# Memorandum to the City of Markham Committee of Adjustment

**File:** A/072/22  
**Address:** 10 Outlook Terrace Drive – Markham, ON  
**Applicant:** Kiran Babu  
**Agent:** Varatha Design Associates (Ken Varatha)  
**Hearing Date:** August 24, 2022

The following comments are provided on behalf of the East District team. The applicant is requesting relief from the following requirements under By-law 177-96 as amended, “Residential Two Exception – (R2\*133) Zone,” as they relate to a proposed basement apartment. The requested variances are to permit:

## SITE PLAN

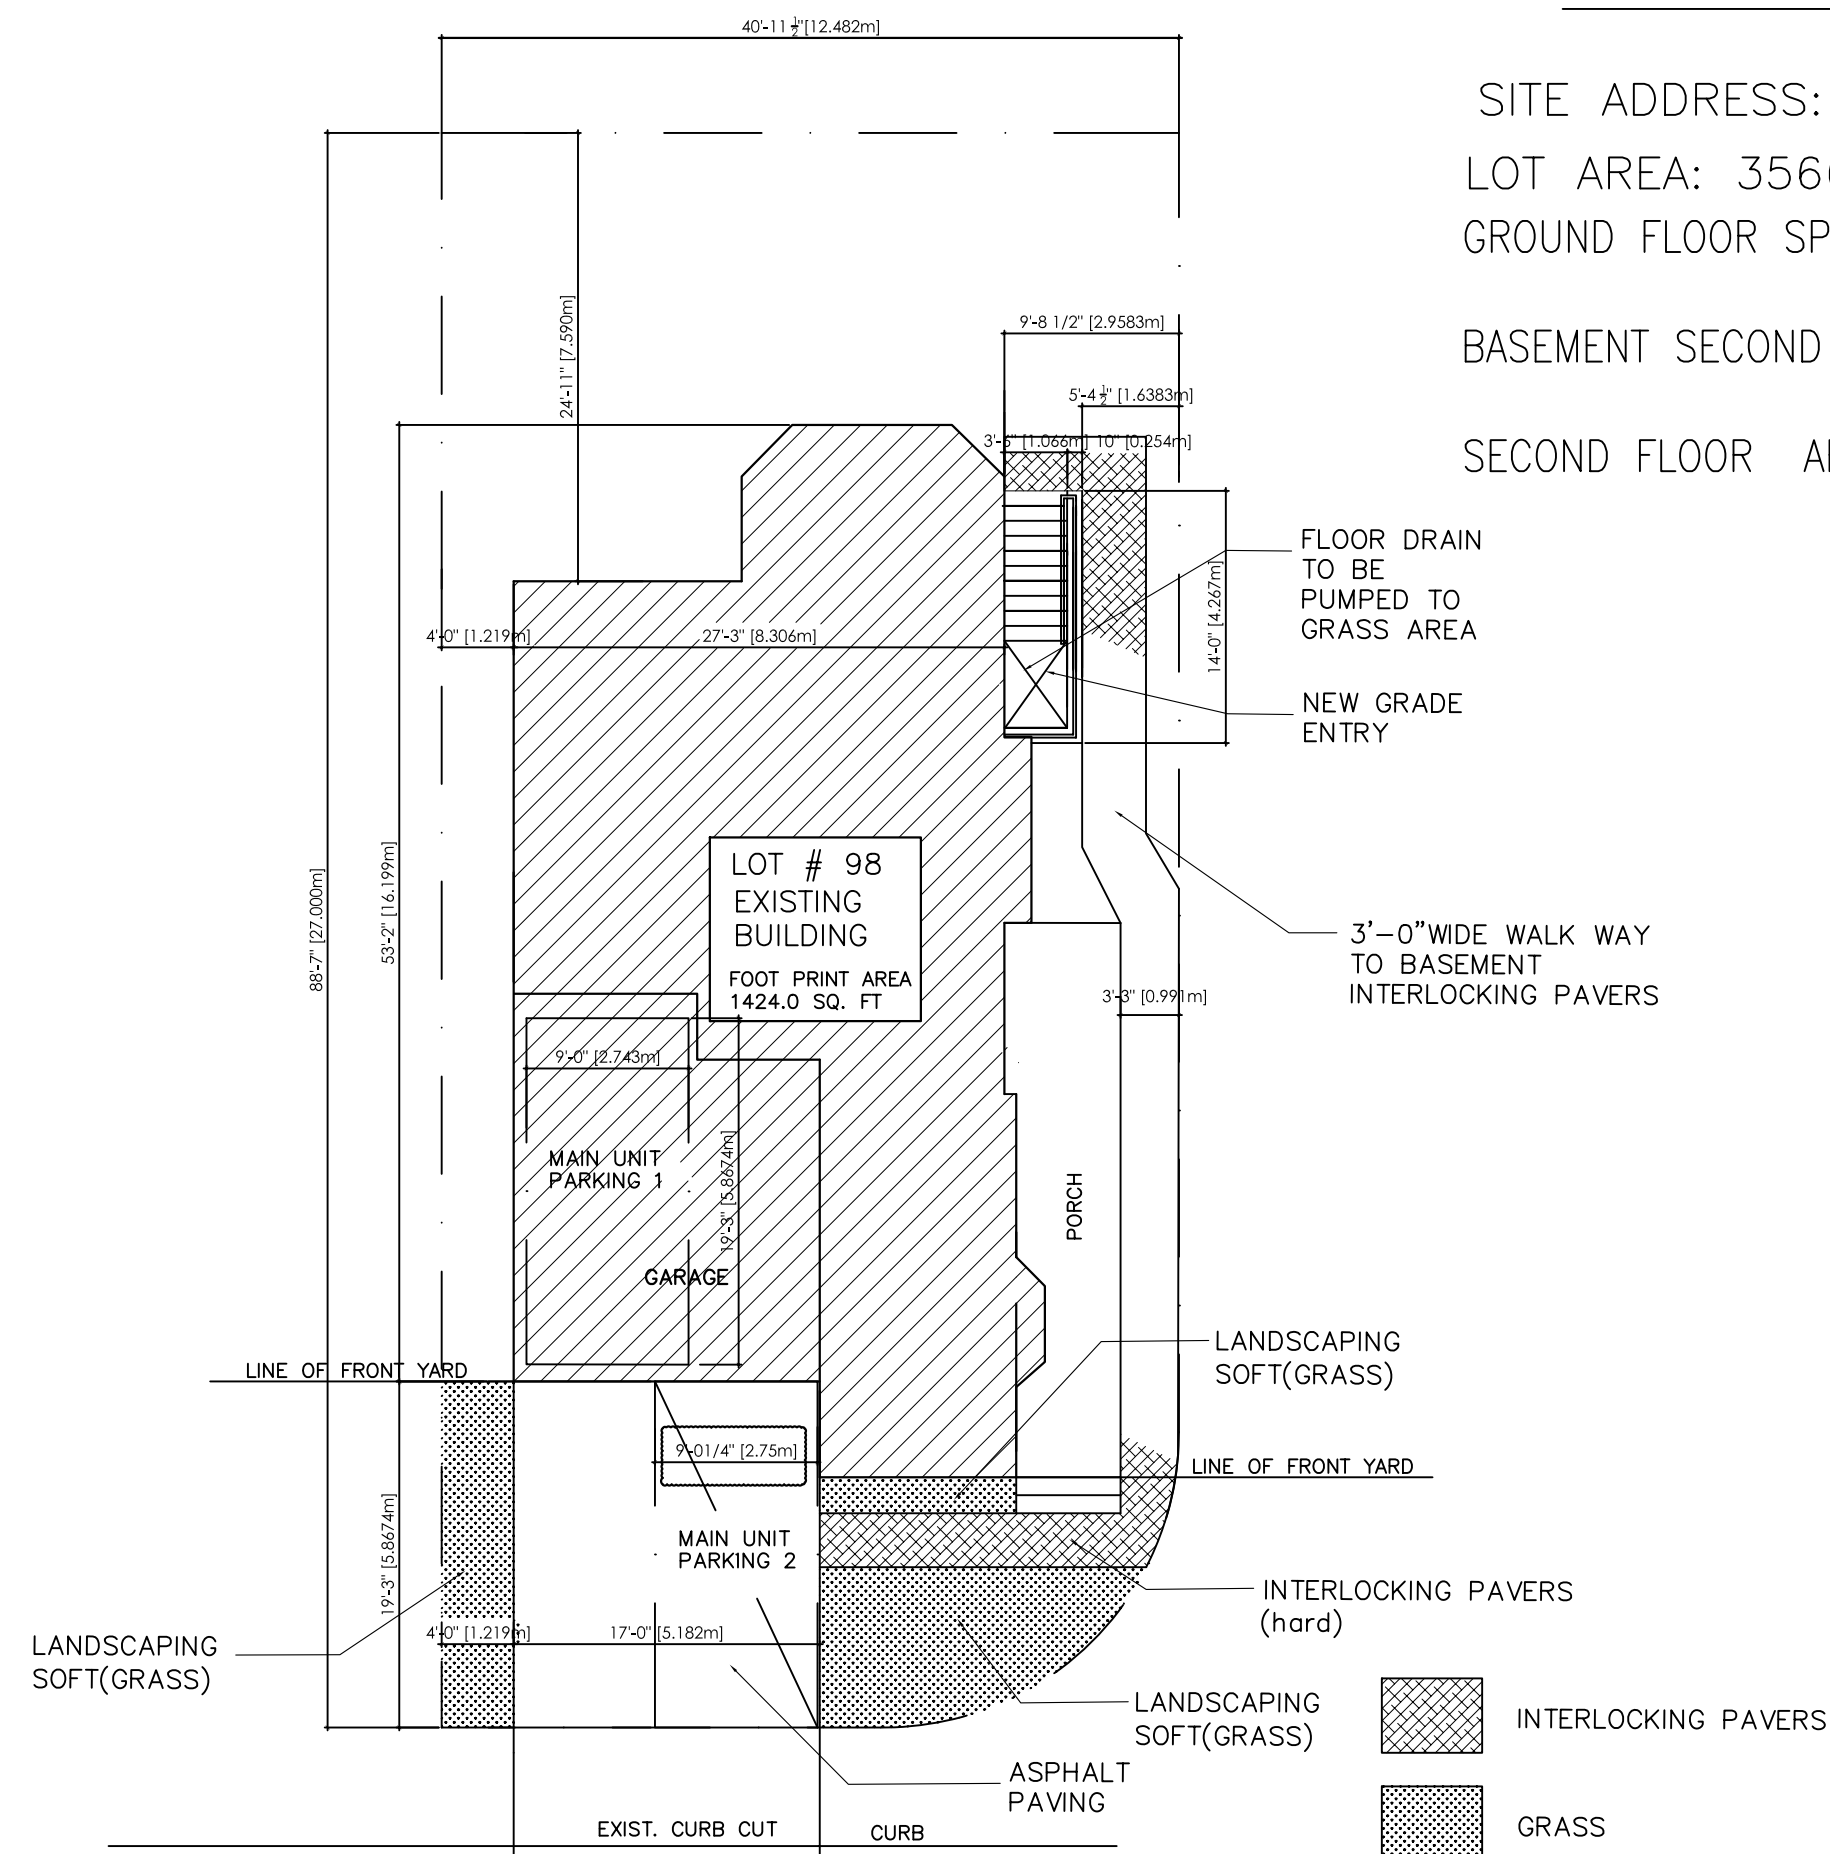
The applicant is also requesting a minimum of 35.0% soft landscaping in the front yard, whereas the By-law requires that a minimum of 40.0% soft landscaping be provided in the front yard in the case of a lot with a lot frontage of 10.10 m (33.14 ft), or greater.

The variance is attributable to the proposed walkway, and existing driveway. If approved, the walkway would serve as a logical extension connecting the driveway area to the proposed main entry points for each unit located along the exterior side yard. Staff are of the opinion that the reduction in soft landscaping is minor in nature, and appropriate for this lot.
